RE: **Lot 18 Block 7, Volcano Cliffs, Unit 18, SAD 228
6531 Papagayo NW
Grading and Drainage Plan
Engineers Stamp Date 11/4/19 (D10D003L10)**

DRAINAGE AND TRANSPORTATION INFORMATION SHEET (REV 6/2018)

ENGINEER'S SEAL	LOT 18 BLK 7 UN 18 VOLCANO CLIFFS 6531 PAPAGAYO RD. N.W.	DRAWN BY DEM
	GRADING AND DRAINAGE PLAN	DATE 10-31-19
11/4/19	 Rio Grande Engineering 1606 CENTRAL AVENUE SE SUITE 201 ALBUQUERQUE, NM 87106 (505) 972-0899	LOT 18 BLK 7 UN 18 VOLCANO CLIFFS
DAVID SOULE P.E. #14522		SHEET # C1
		JOB #

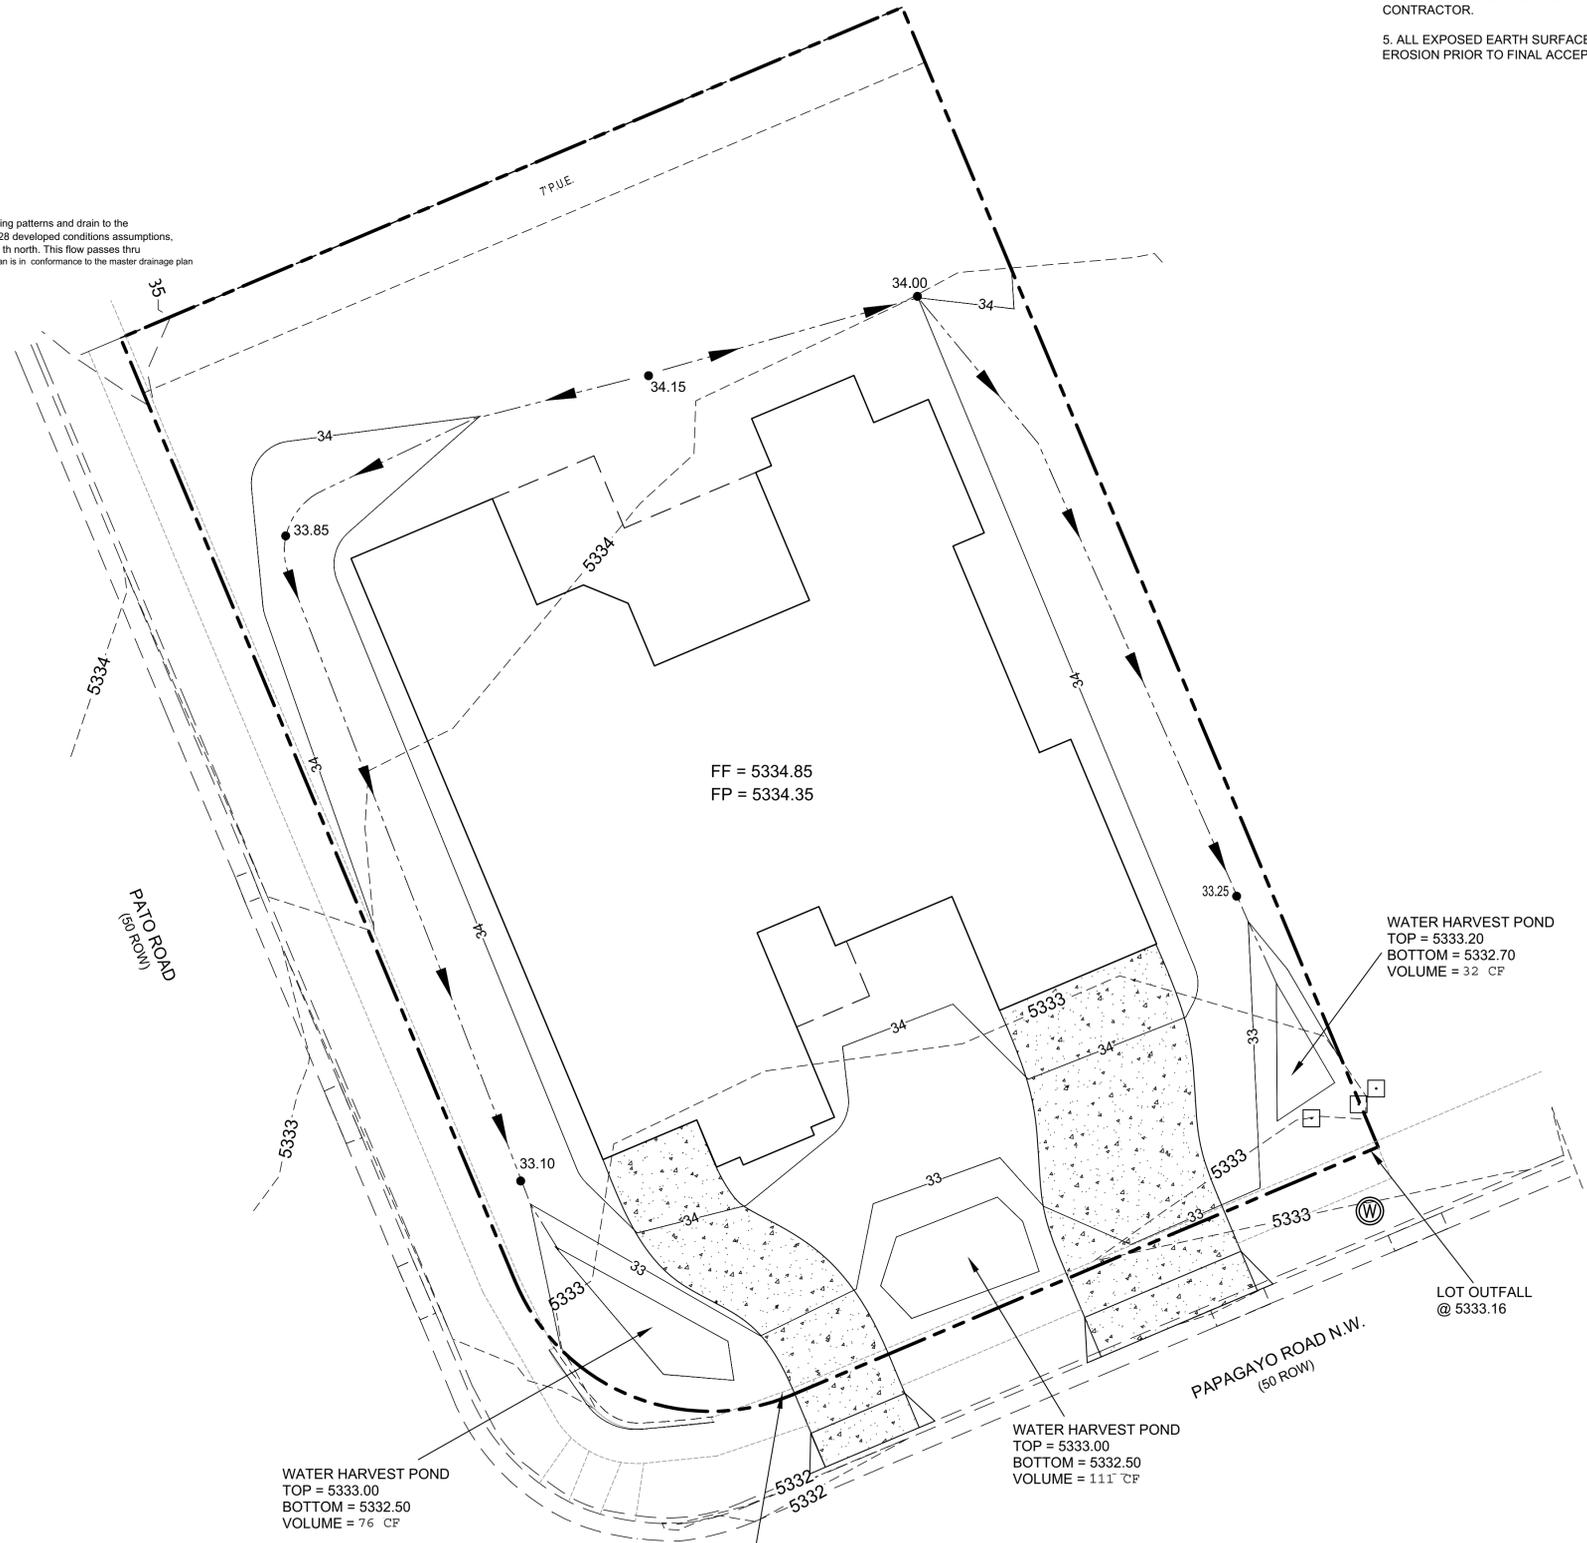
Based upon the information provided in your submittal received 11/4/19, this plan is approved for Grading Permit.

Prior to Building permit approval a Pad Certification will be required, provided by the Engineer or a registered Land Surveyor.

Reiterate to the Owner/Contractor that a separate permit for a garden/retaining wall must be obtained with the approved G&D plan and Pad Certification. Also, if a swimming pool is to be placed the grading and drainage plan will change and will need to be resubmitted.

Prior to Certificate of Occupancy release, Engineer Certification per the DPM checklist is required.
